BRUNSWICK STEAM ELECTRIC PLANT, UNIT 1 AND 2
NRC DOCKETS 50-325 AND 50-324
OPERATING LICENSES DPR-71 AND DPR-62
REQUEST FOR LICENSE AMENDMENTS
PRESSURE-TEMPERATURE LIMITS CURVES

TYPED TECHNICAL SPECIFICATION AND BASES PAGES - UNIT 2

MARKED-UP TECHNICAL SPECIFICATION AND BASES PAGES - UNIT 1

MARKED-UP TECHNICAL SPECIFICATION AND BASES PAGES - UNIT 2

FIGURE 3.4.6.1-3a
PRESSURE-TEMPERATURE LIMITS
REACTOR VESSEL

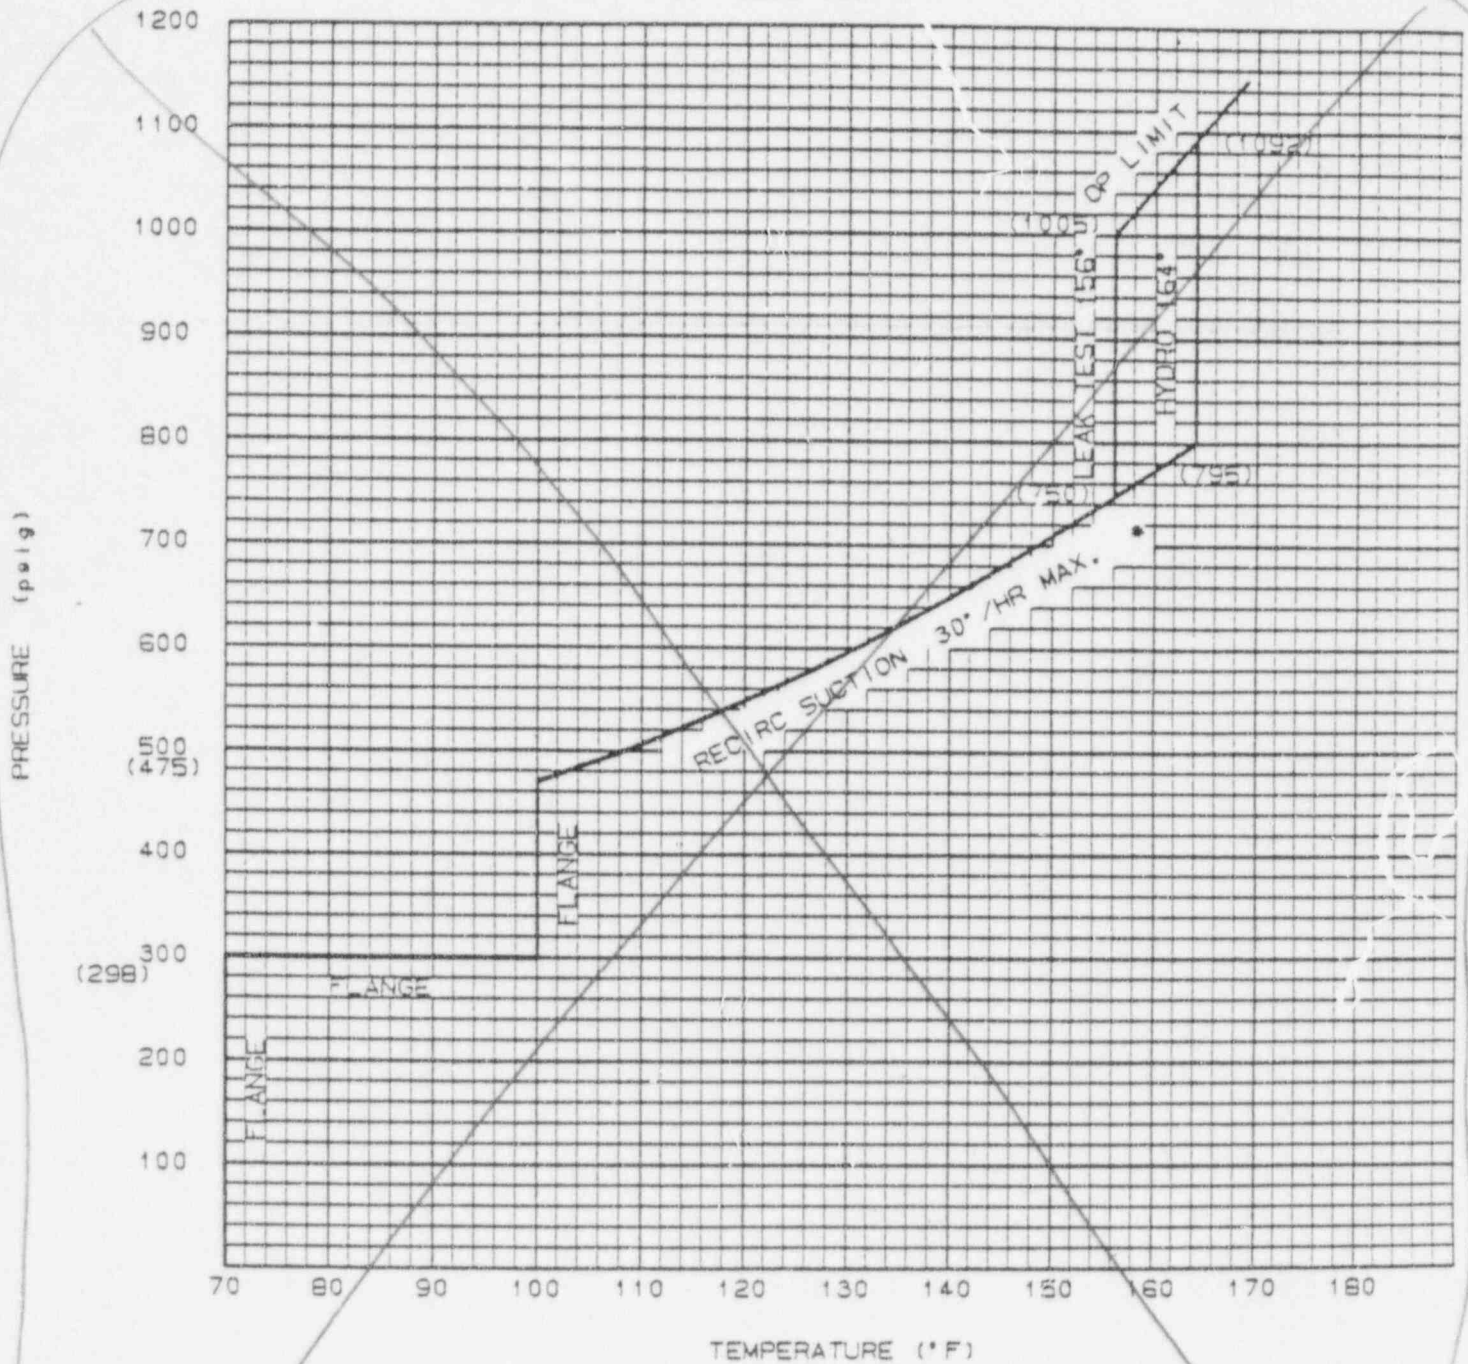
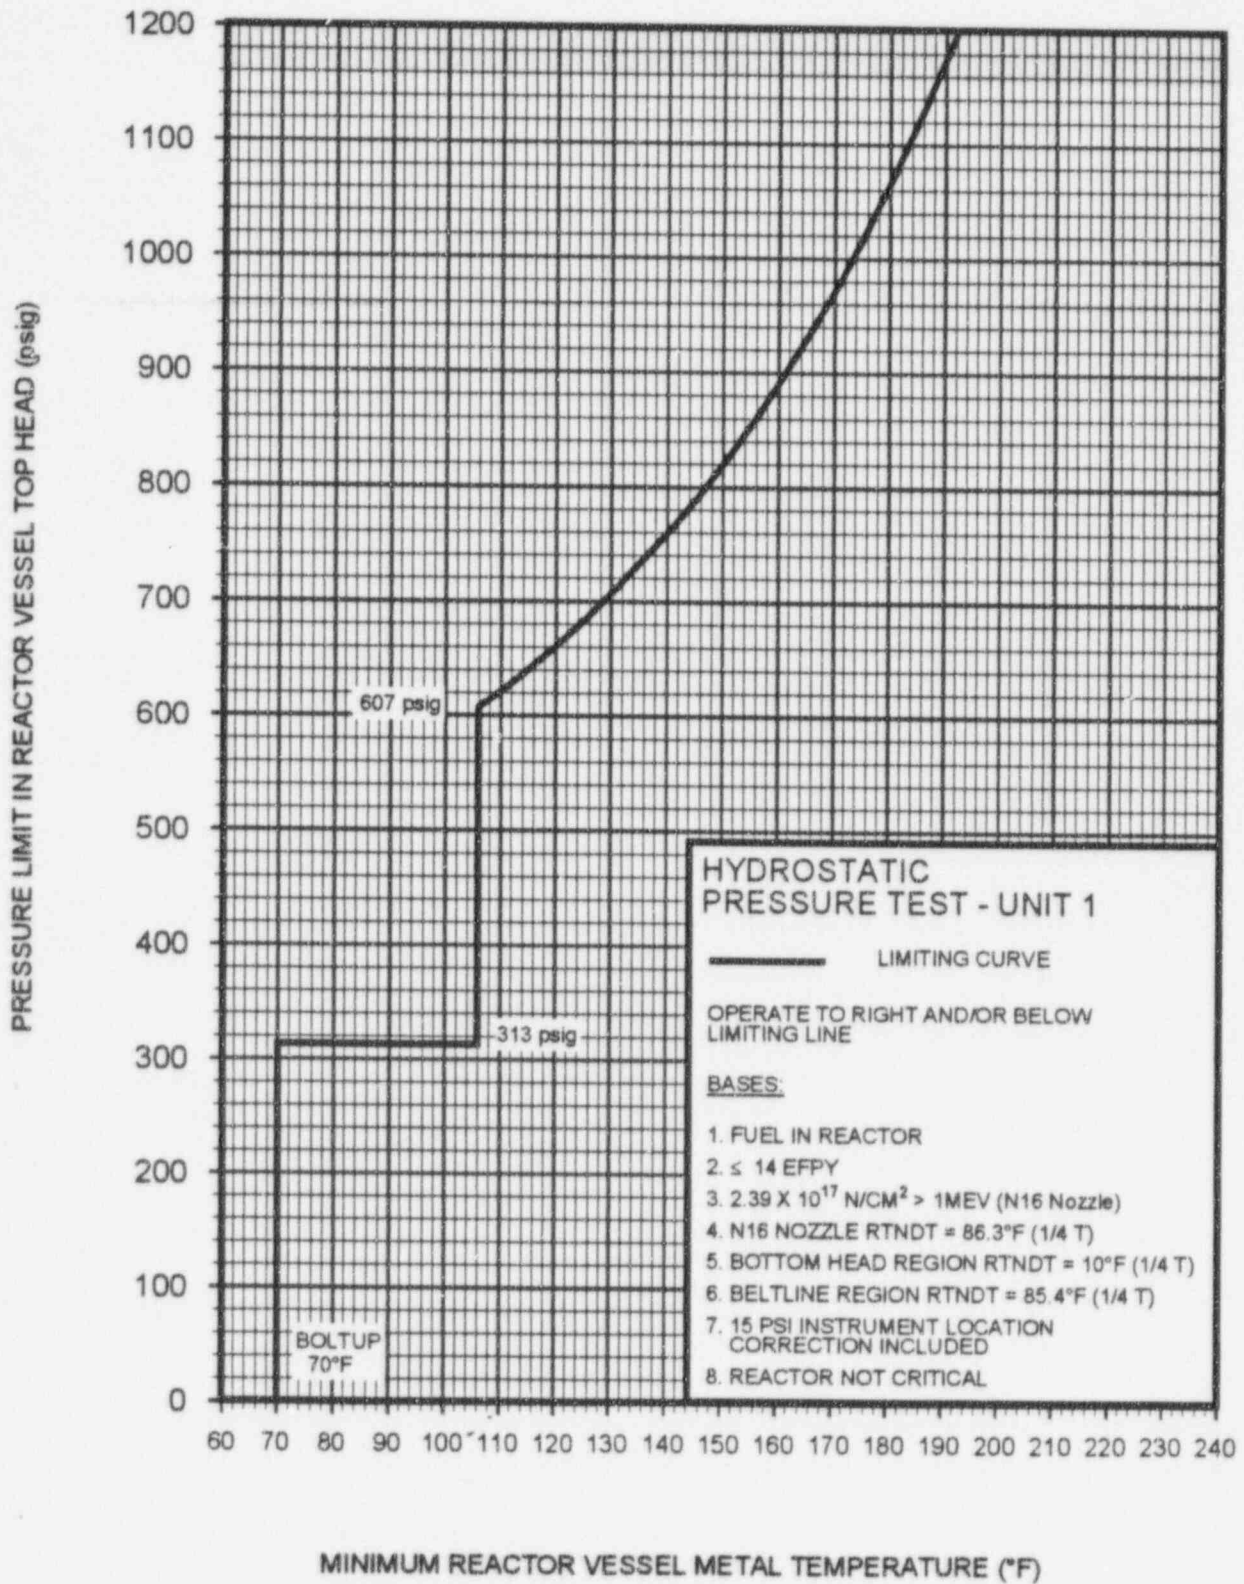
Insert 3.4.6.1-3a

FIGURE 3.4.6.1-3b
PRESSURE-TEMPERATURE LIMITS
REACTOR VESSEL

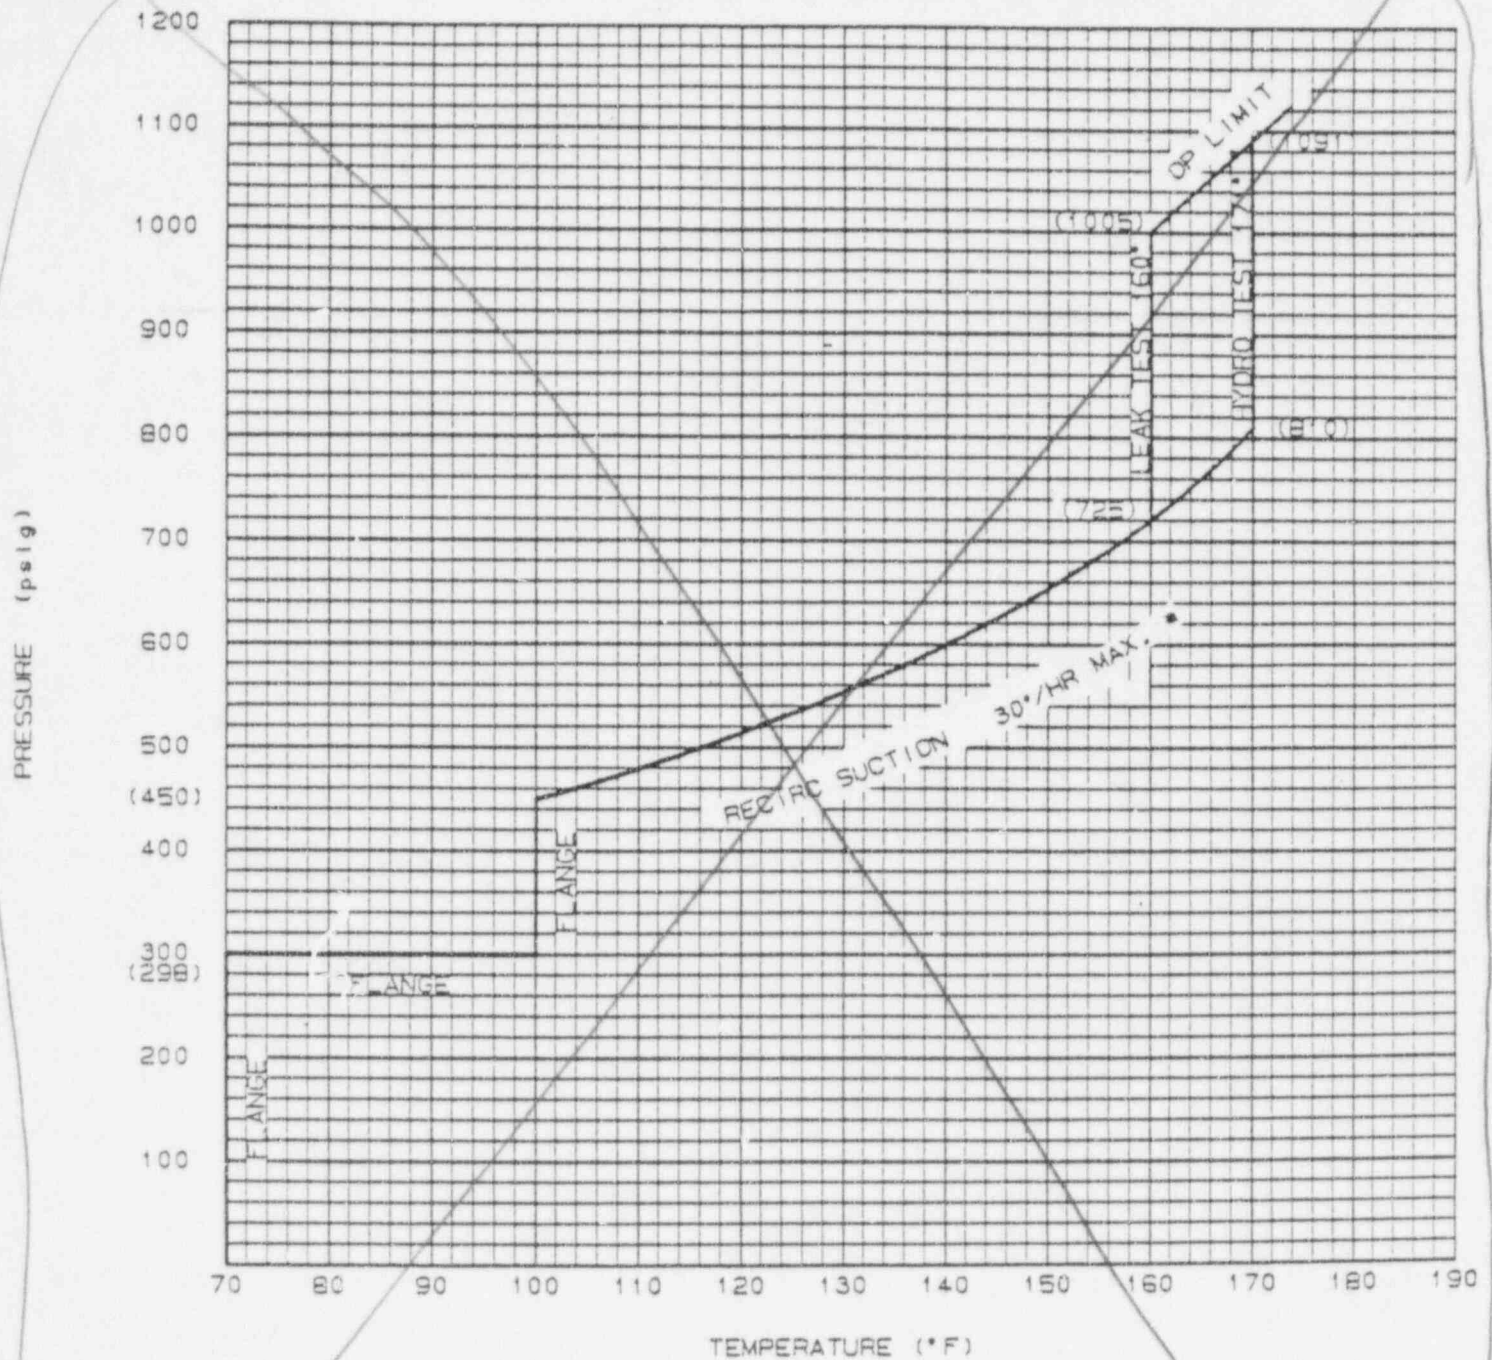
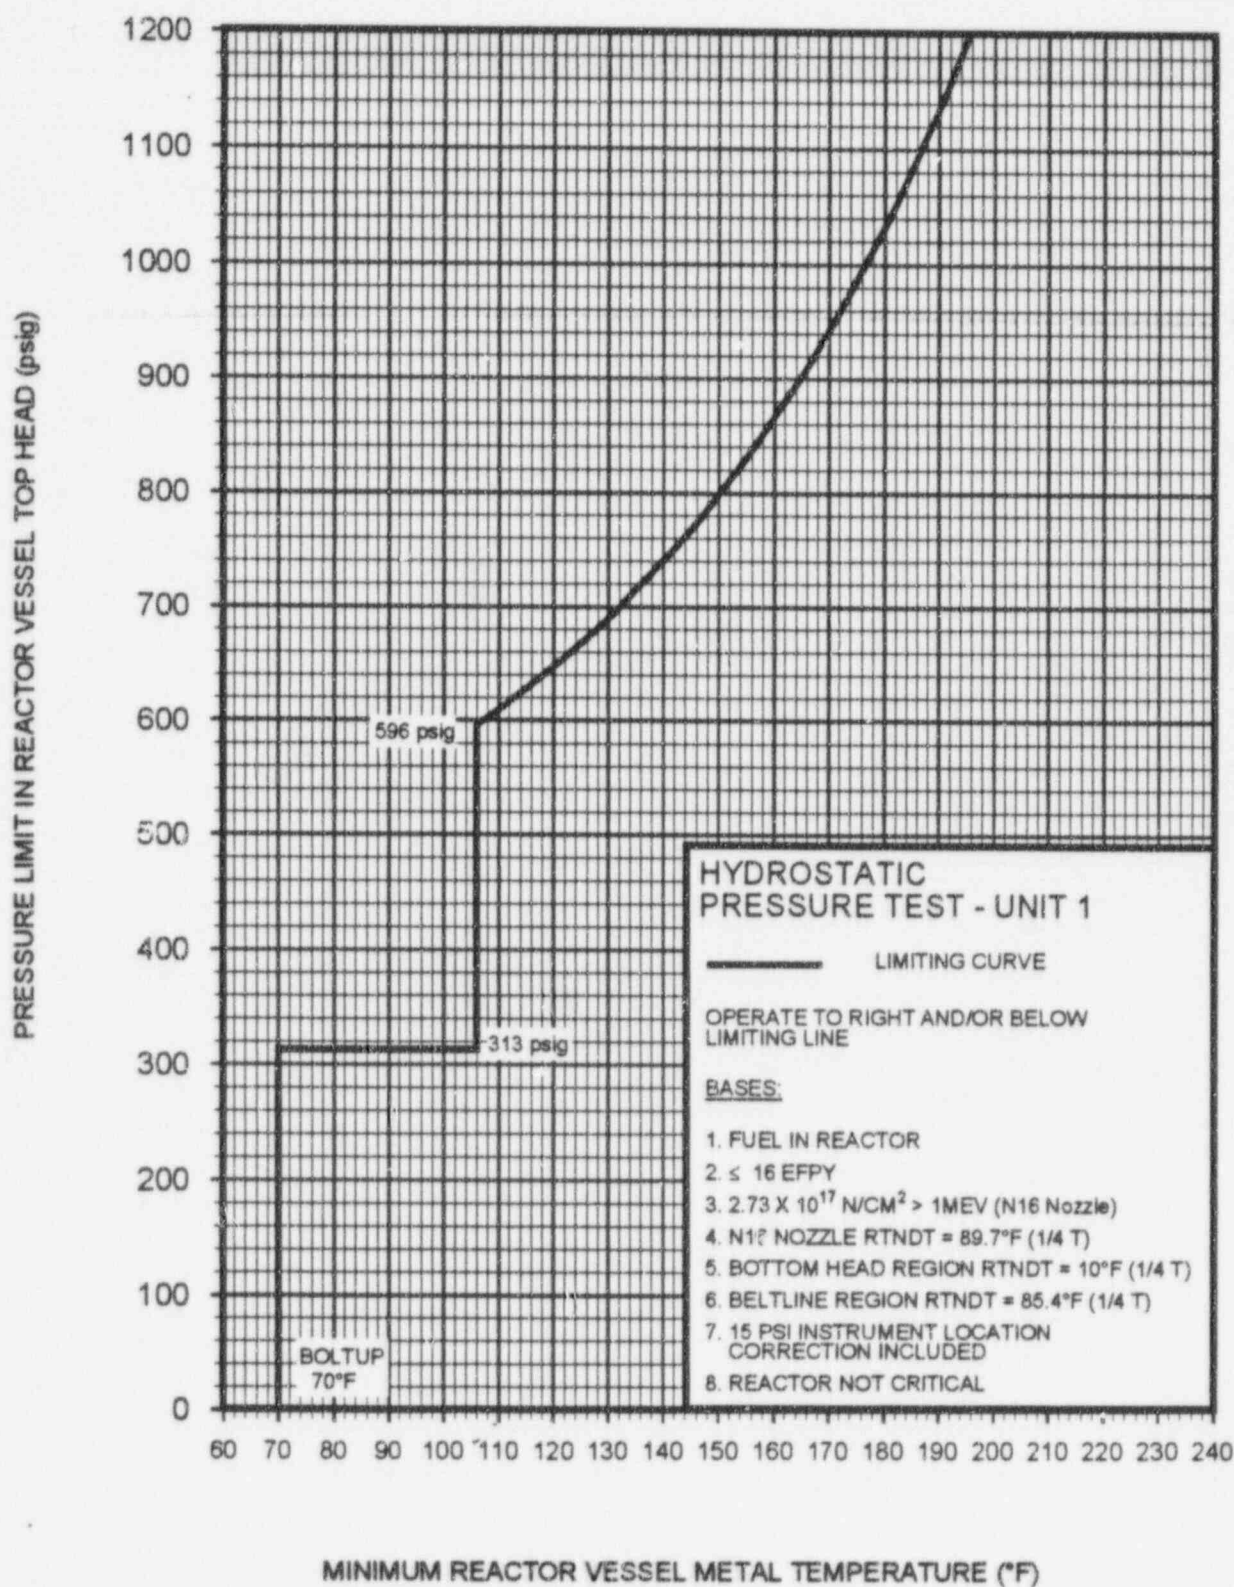
Insert 3.4.6.1-3b

FIGURE 3.4.6.1-3c
PRESSURE-TEMPERATURE LIMITS
REACTOR VESSEL

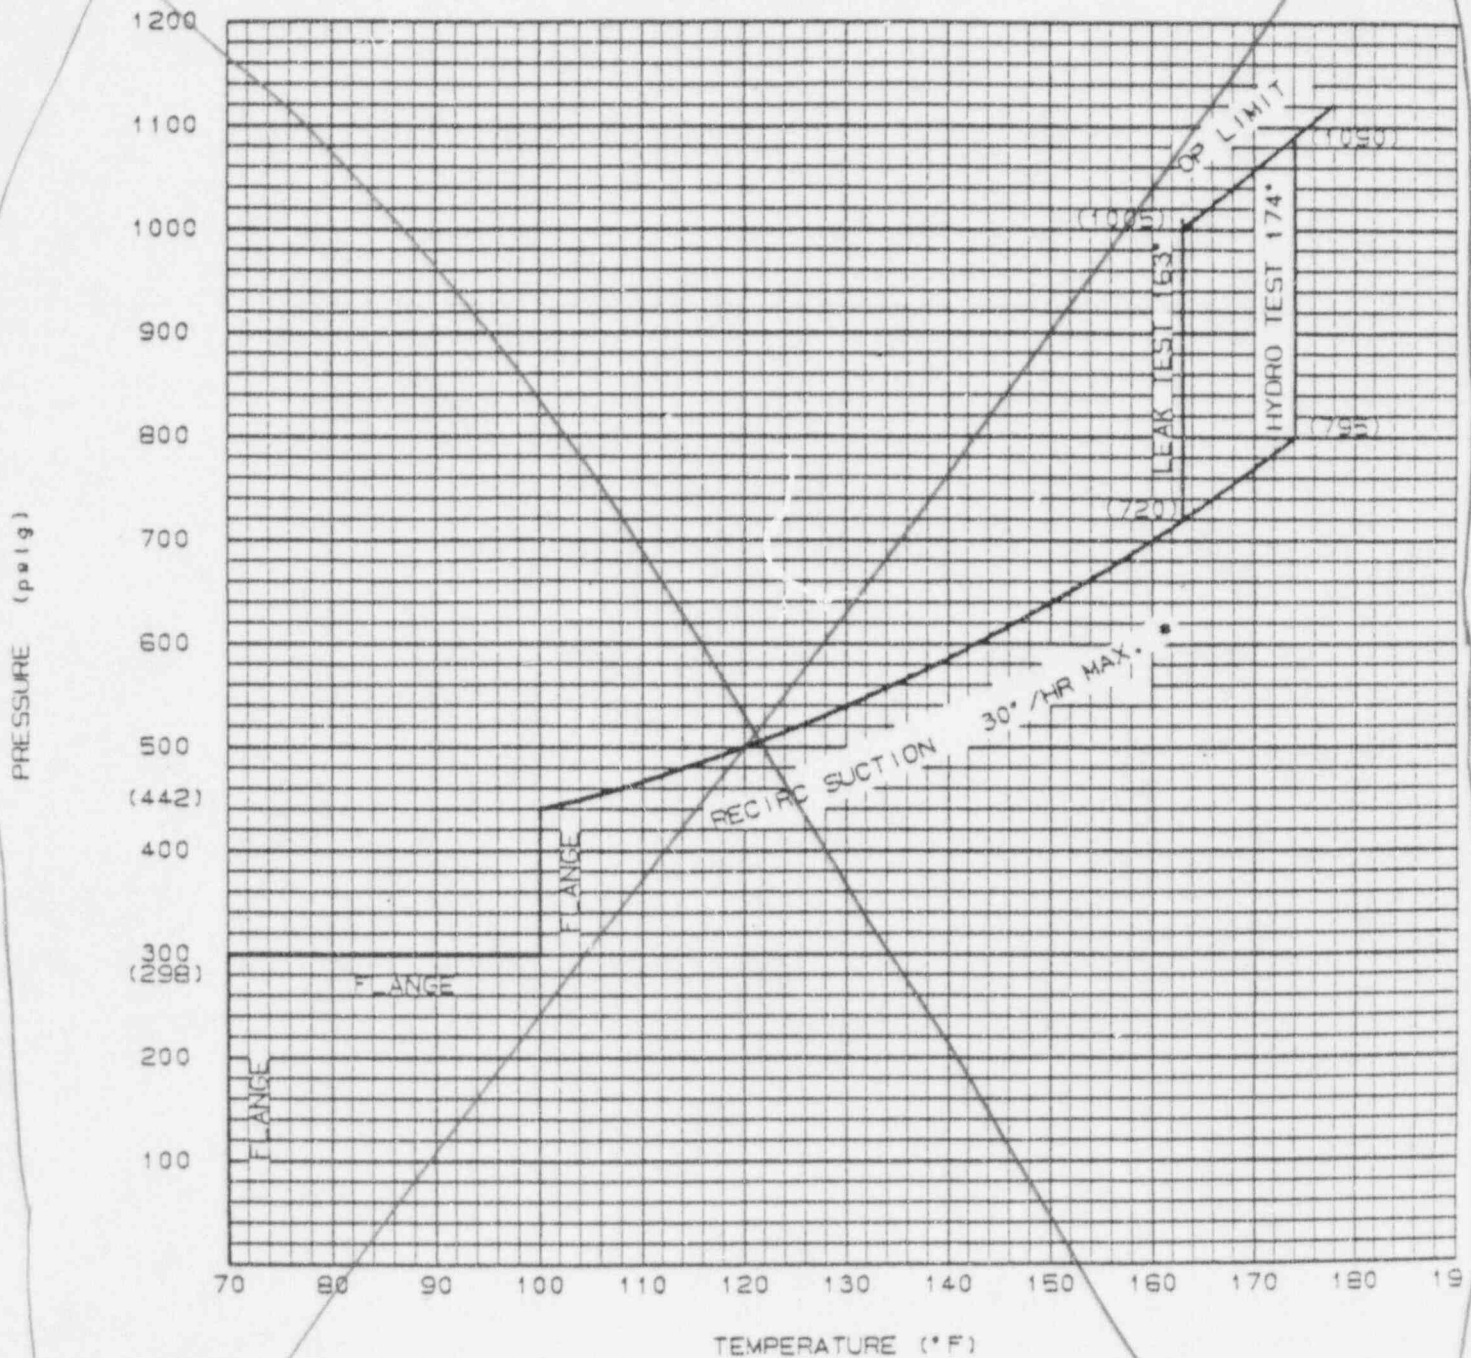
3.4.6.1 The reactor coolant system temperature and pressure shall be limited in accordance with the limit lines shown on (1) Figure 3.4.6.1-1 for heatup by non-nuclear means, cooldown following a nuclear shutdown, and low power PHYSICS TESTS; (2) Figure 3.4.6.1-2 for operations with a critical core other than low power PHYSICS TESTS or when the reactor vessel is vented; and (3) Figures 3.4.6.1-3a, 3.4.6.1-3b, ~~or 3.4.6.1-3c~~, as applicable for inservice hydrostatic or leak testing, with:

This page intentionally deleted.
